SUBJECT: WOLF CREEK GENERATING STATION - AMENDMENT NO. 120 TO FACILITY
OPERATING LICENSE NO. NPF-42 (TAC NO. MA1294)

The amendment revises the TS to support a modification to the plant to increase the storage capacity of the spent fuel pool and increase the nominal fuel enrichment to 5% weight percent of U-235. The amendment also revises the TS to allow the storage of an additional 279 assemblies in the cask loading pit.

SAFETY EVALUATION BY THE OFFICE OF NUCLEAR REACTOR REGULATION
RELATED TO AMENDMENT NO. 120 TO FACILITY OPERATING LICENSE NO. NPF-42

FIGURE 3.9-1
 MINIMUM REQUIRED FUEL ASSEMBLY BURNUP AS A FUNCTION OF
 INITIAL ENRICHMENT TO PERMIT STORAGE IN REGIONS 2 AND 3

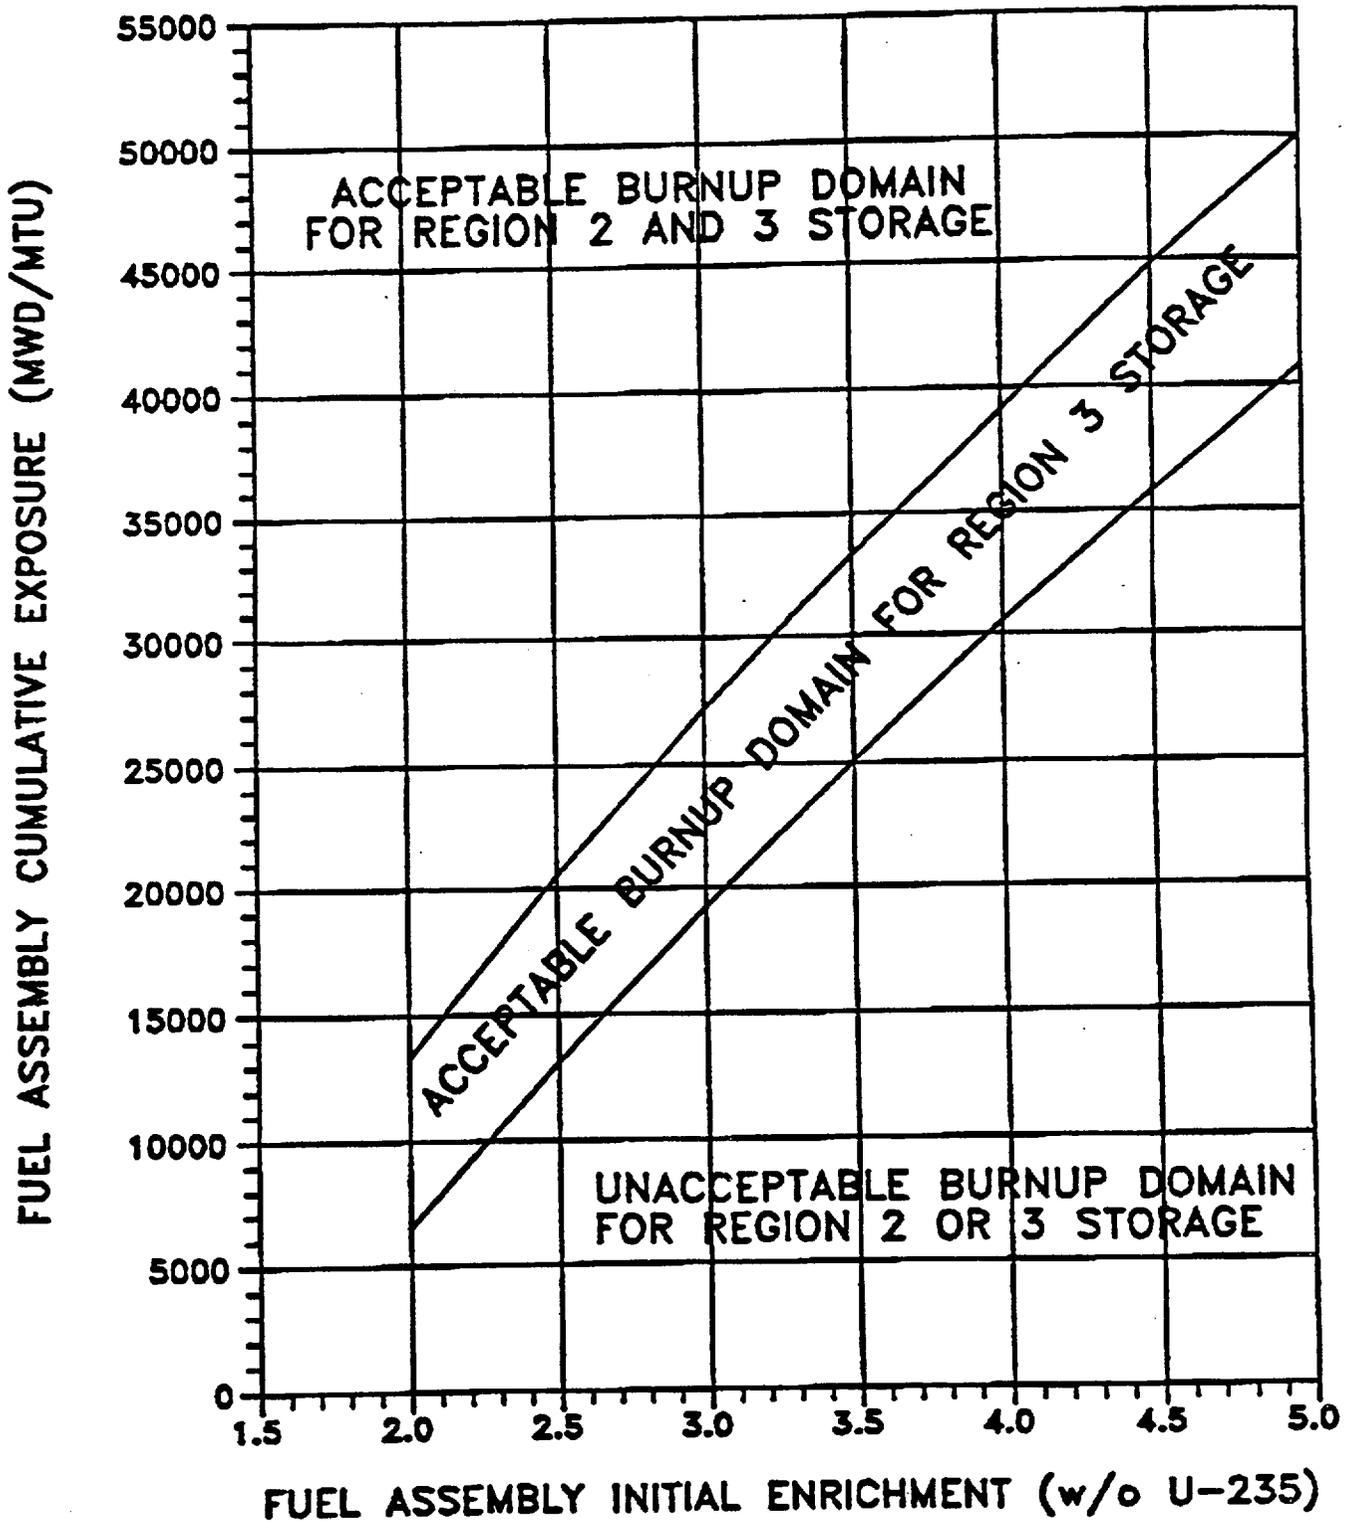
Proposed TS Figure 3.9-1 shows that Regions 2 or 3 can safely accommodate fuel of various initial enrichments up to 5.0 w/o U-235 and discharge burnups provided the combination falls within the acceptable domain illustrated by the upper line. Assemblies meeting the burnup requirements of the lower line may only be stored in Regions 1 or 3. This reactivity equivalencing method is the standard method used for storage rack reactivity evaluations and is acceptable.

1. TS 3.9.12 has been revised to reflect the conditions required for fuel assembly storage in Regions 1, 2, and 3. The associated TS Figure 3.9-1, which shows the minimum required fuel assembly burnup as a function of initial enrichment for allowed storage in Regions 2 and 3, has been revised.

2. TS 5.6.1.1a has been modified to allow spent fuel storage of assemblies with maximum nominal enrichment of 5.0 w/o U-235 in Region 1 and storage in Regions 2 and 3 based on acceptable combinations of initial enrichment and discharge exposure as shown in Figure 3.9-1.
